Permit Type Building/Residential/Alteration/SFD

Permit Number B25005574

SFD/ ALTERATIONS TO ENTIRE HOME TO INCLUDE: BASEMENT - RELOCATE STAIRS, REMOVE OFFICE, EXPAND FAMILY ROOM, RELOCATE EXTERIOR DOORS, ADD NEW WINDOWS, REMOVE BILLIARD ROOM WALLS TO CREATE LIBRARY, EXPAND GYM, CONVERT HALF BATH TO FULL BATH, NEW HVAC ROOM, AND CLOSET. FIRST FLOOR- RELOCATE STAIR, RELOCATE DINING ROOM TO CREATE OPEN LIVING/DINING AREA W/ WETBAR, RELOCATE POWDER ROOM, CREATE NEW PANTRY, PREP KITCHEN, AND WET BAR, CONVERT SUNROOM TO OFFICE NEW 2 SIDED FIREPLACE W/ NEW CHIMNEY IN LIVING ROOM AND SCREENED PORCH. SECOND FLOOR- RELOCATE STAIRS, REMOVE BEDROOM TO CREATE LARGER OPEN LOFT, REMODEL HALLWAY BATHROOM. CONSTRUCT 15 X 14 SCREEN PORCH ON MAIN LEVEL APPROX. 2580sf

619 Severn Ave Suite 202 Annapolis, MD 21403 410.571.3604	PROJECT TITLE SIMPSON-SIVAK RESIDENCE 1259 EMMAUS ROAD WOODBINE, MD, 21797	DESCRIPTION ARCHITECTURAL SITE PLAN - PROPOSED		DRAWING NO. A0.00B
			SCALE 1" = 20'-0"	DATE 02/10/26	REFERENCE DRAWING RFI

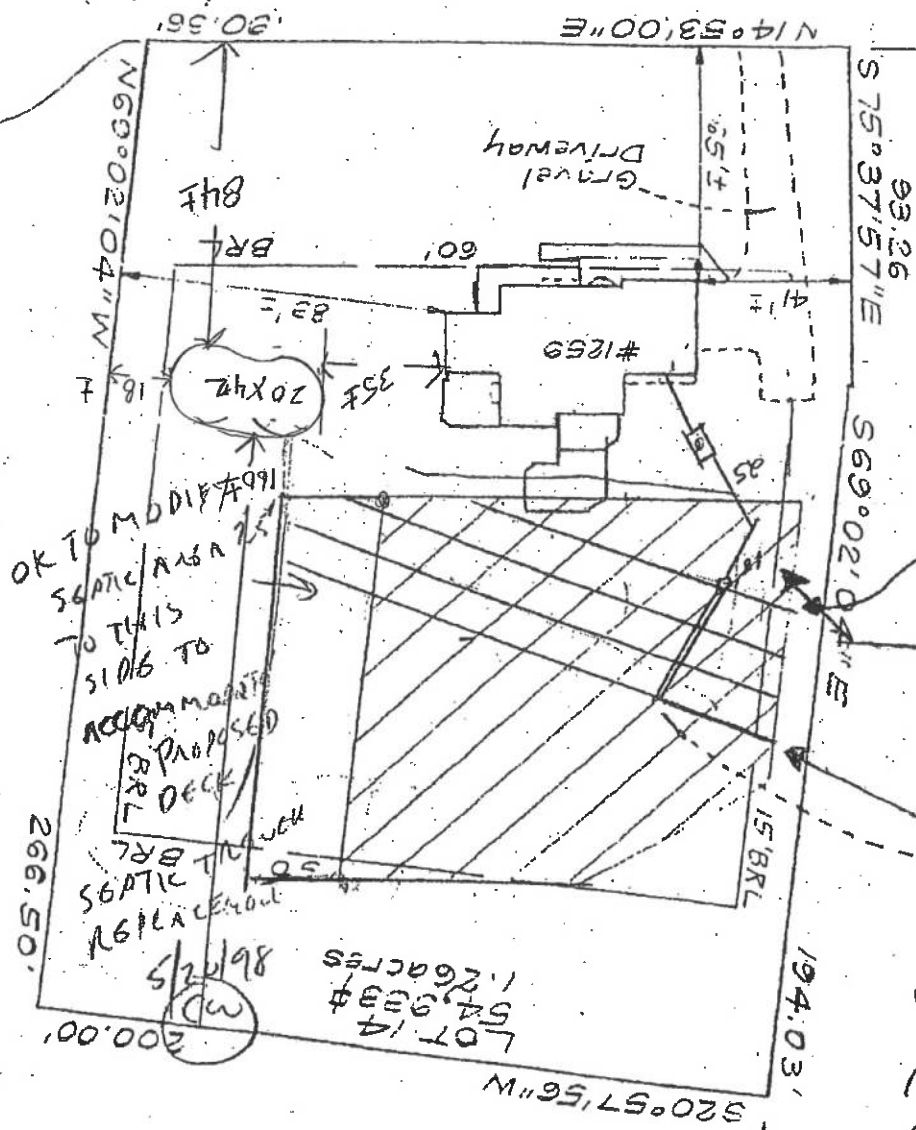
OK TO MODIFY
SEPTIC AREA
TO THIS
SIDE TO
ACCOMMODATE
PROPOSED
DECK
SEPTIC TRENCH
SEPTIC LINE
TO BE ADDED

Highest trench
to be deleted

Septic Area
to be deleted

septic line
to be added

OK AS PROPOSED

NO BASED ON

COMMITMENT TO

REPAIR SEPTIC SYSTEM

AS SHOWN PRIOR TO

COMPLETION OF

CONSTRUCTION OF DECK

(SEPTIC PERMIT P59009)

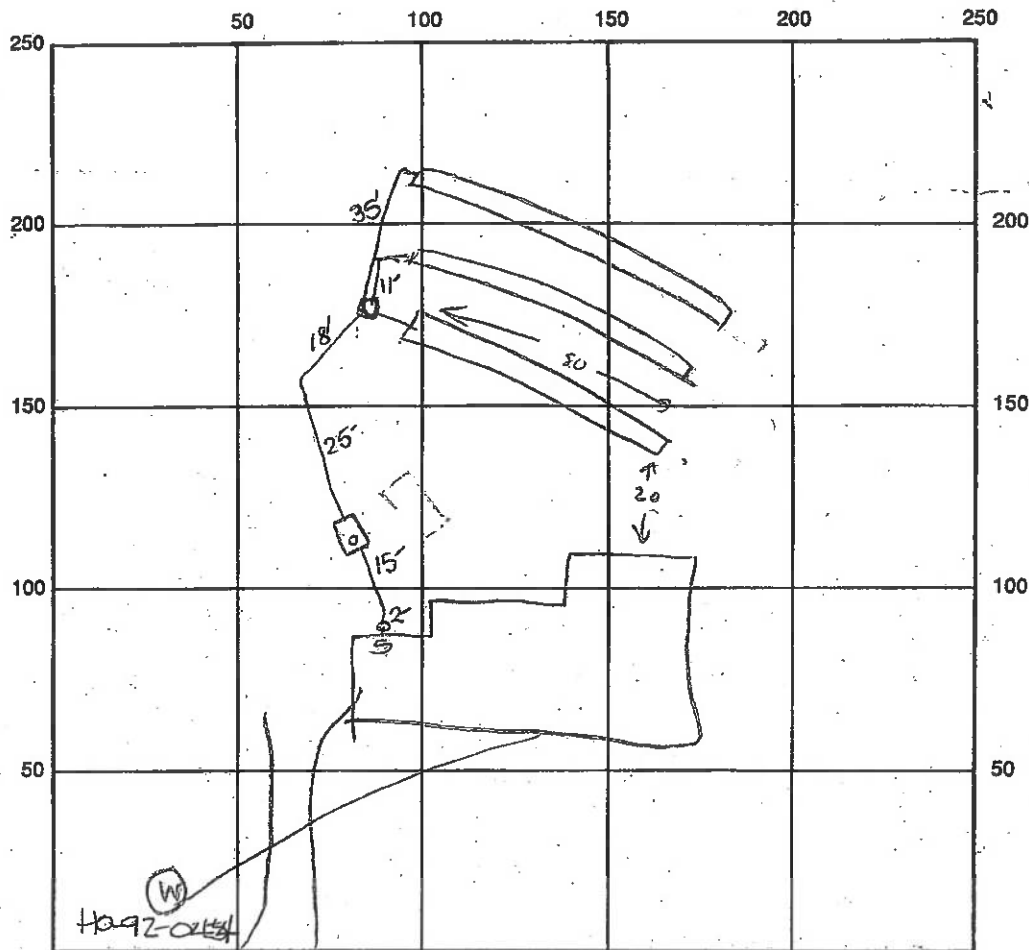
* DELETE TRENCH - DISCONNECT & LEAVE
